Subject: KNOCKING NOISE FROM REAR SUSPENSION WHILE DRIVING ON ROUGH ROAD	Bulletin No.: 02-005/20
	Last Issued: 07/22/2020

2016-2020 Mazda2 vehicles (Mexico spec) with VINS lower than 3MDDJ*****401991 (produced before Jan. 14, 2020)

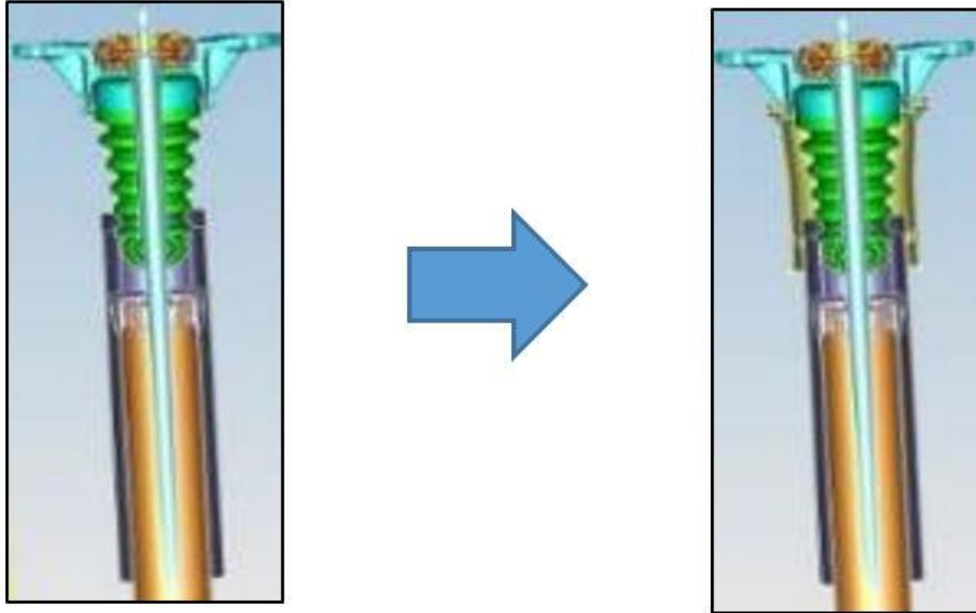
Some customers may complain about a knocking noise heard from the rear suspension while driving on rough road. The noise may be caused by a broken bound (bump) stopper that breaks because of deterioration from environmental factors and bad road conditions.

To eliminate this concern, a dust boot has been added in order to protect the bound (bump) stopper from water and the mounting rubber has been changed accordingly.

- If the bound (bump) stopper is broken, replace the bound (bump) stopper with a new one, the mounting rubber with a modified one, and install a new dust boot. Refer to the instructions on MGSS (REAR SHOCK ABSORBER DISASSEMBLY/ASSEMBLY).
- If the bound (bump) stopper is not broken, look for other sources of the noise.
